### **REMARKS/ARGUMENTS**

Appl. No. 10/072,707  
Amd. Dated November 21, 2005  
Reply to Office Action of September 21, 2005

**Fig. 1**

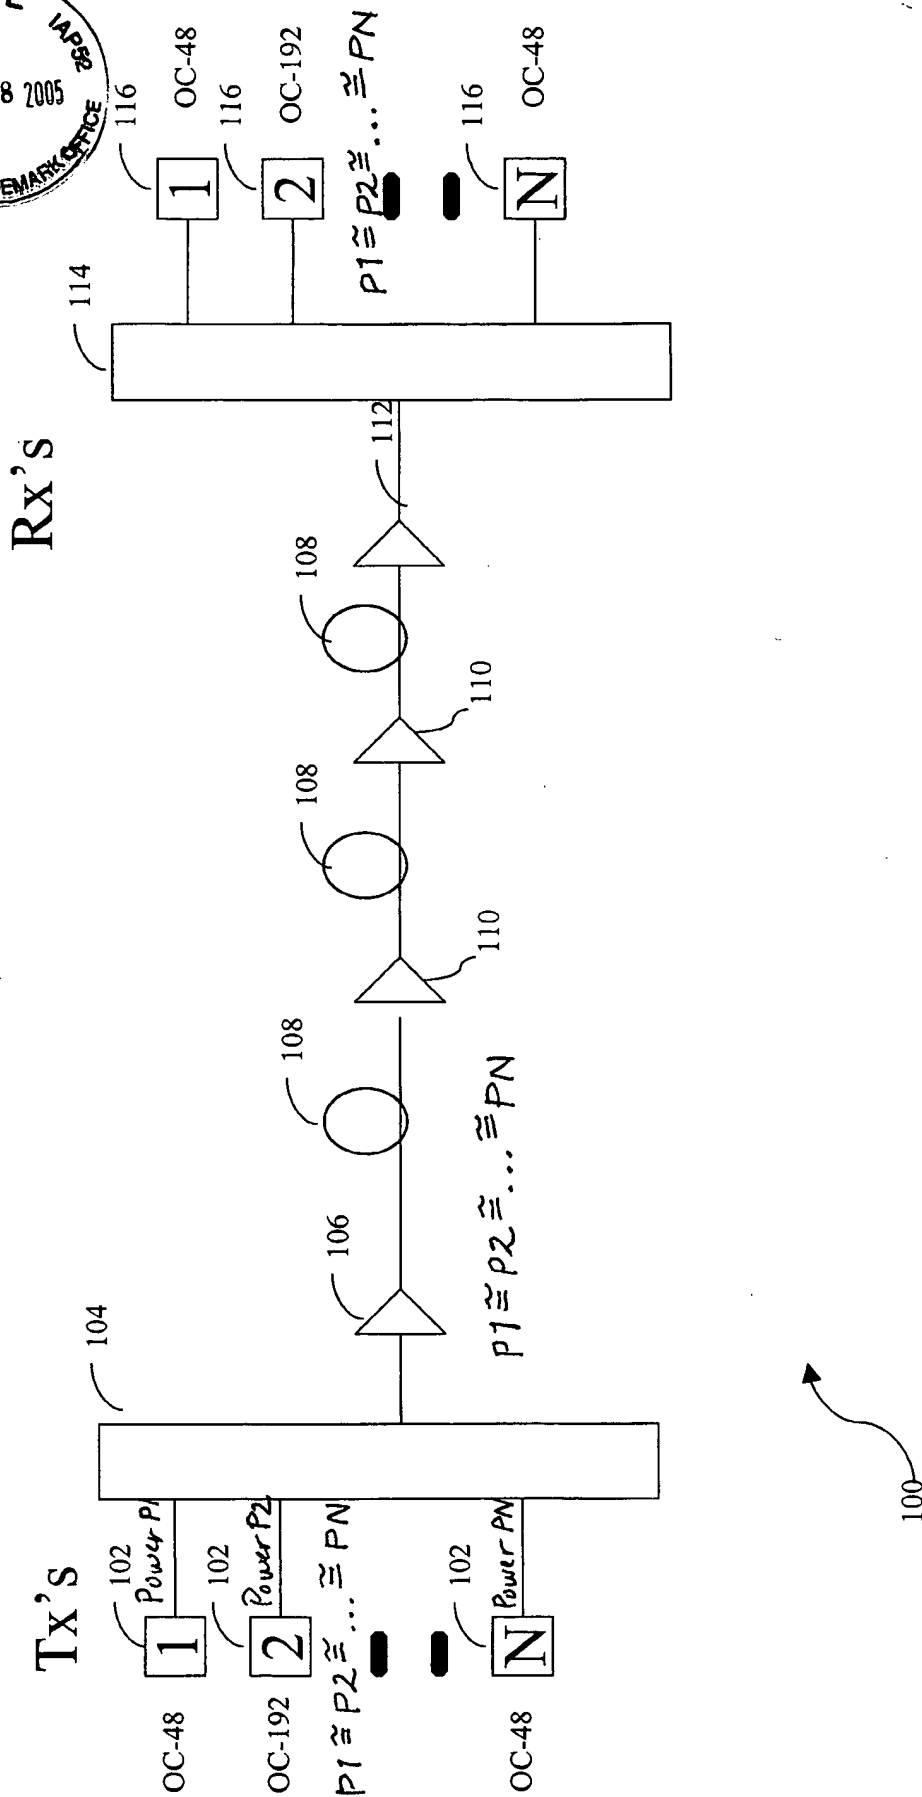
In response to the Examiner's continued objections to the drawings, a new drawing of Fig. 1 is submitted. The applicants note that support for these changes are found in at least originally submitted claims 7 and 21. With respect to the objection to previously submitted drawing for Fig. 4A, the applicants are uncertain as to what the Examiner's objections are and respectfully request that he withdraw his objections.

The attached sheet of drawings replaces previously submitted sheet including Fig. 1. The replacement drawing includes changes: to Fig. 1 on the left side of the drawing to indicate the general equality for the modulated optical signals when multiplexed together and for the modulated optical signals after amplification.
